Docket Number:	21-TPG-01
Project Title:	Roseville Energy Park Temporary Power Generators
TN #:	239616
Document Title:	CEC Staff's Recommendation to Grant License
Description:	STAFF'S RECOMMENDATION TO GRANT LICENSE FOR ROSEVILLE STATE POWER AUGMENTATION POWER SITE (21-TPG-01)
Filer:	Steve Kerr
Organization:	California Energy Commission
Submitter Role:	Commission Staff
Submission Date:	9/8/2021 9:20:46 AM
Docketed Date:	9/8/2021

Subject: STAFF'S RECOMMENDATION TO GRANT LICENSE FOR ROSEVILLE STATE POWER AUGMENTATION POWER SITE (21-TPG-01)

Figure 1: Site Plan
Source: TN239574 Roseville's CEC Permit Application - Part 1

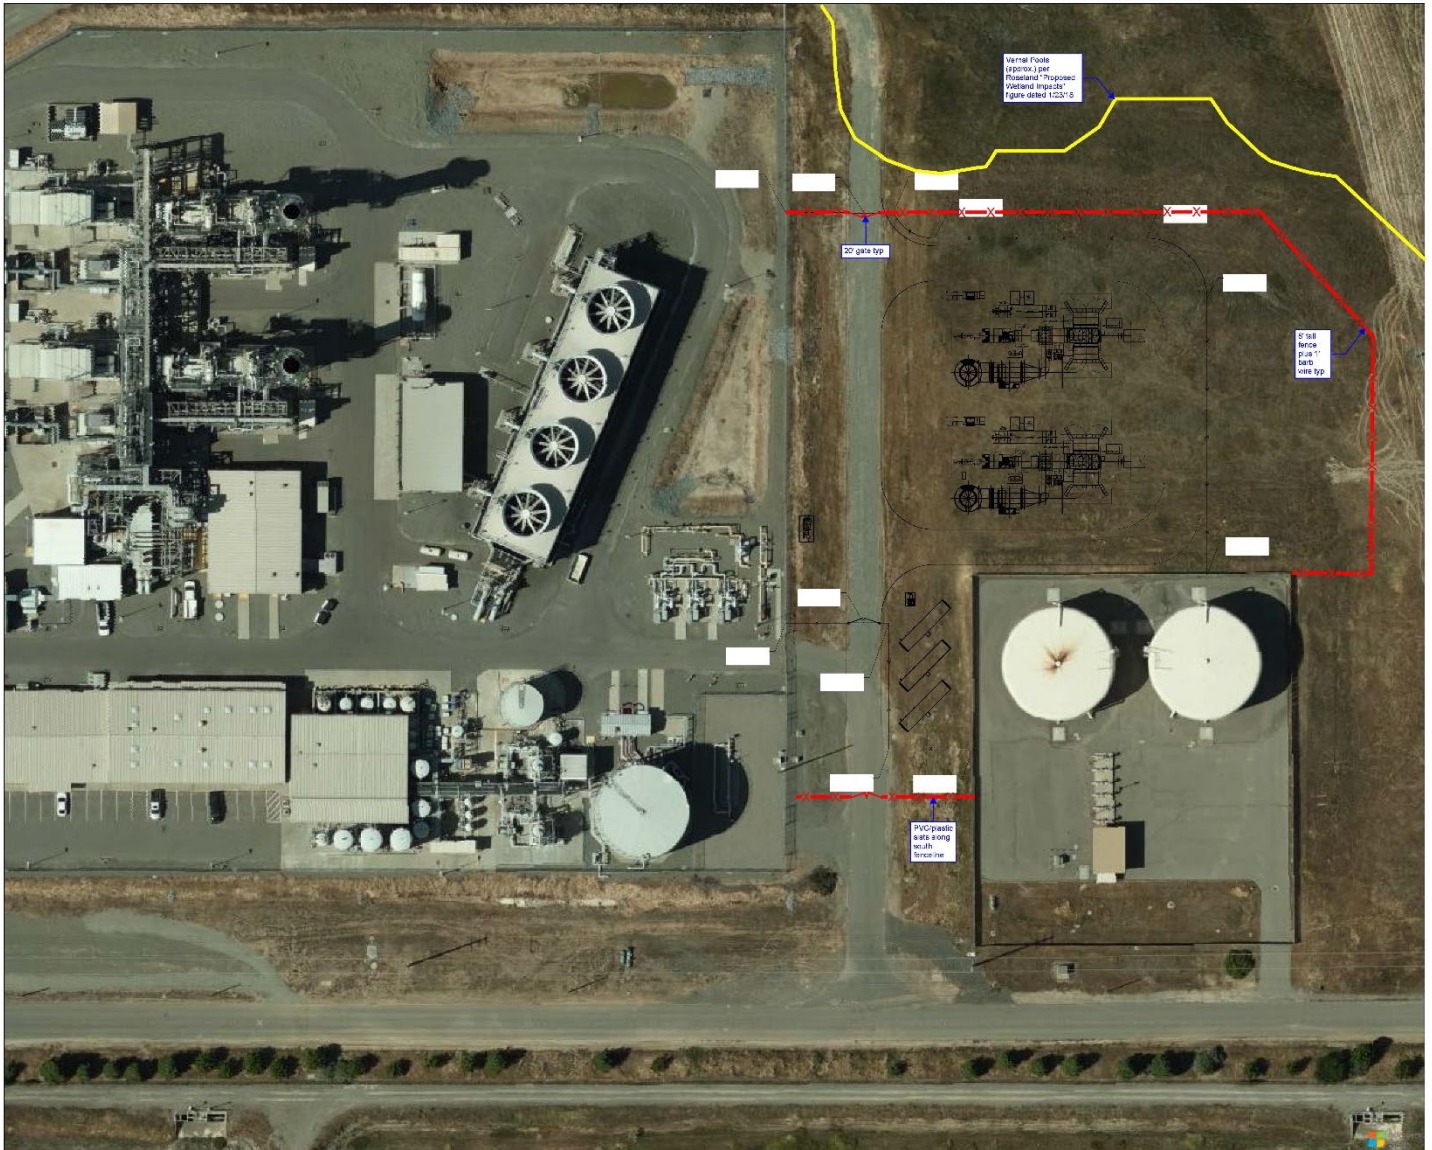
The TPGs would be installed behind two existing water tanks located near the south-eastern corner of the REP site along Phillip Road (see **Figure 1**). Aerial images from 2006 and photographs provided by the applicant show the site was previously disturbed for use as a parking lot and laydown area for the original construction of REP between 2005-2007 [criterion (a)(3)]. The RSPAPS total area is approximately 1.4 square acre. The nearest residence is on an unnamed road, approximately 1,500 feet northeast of the project site.
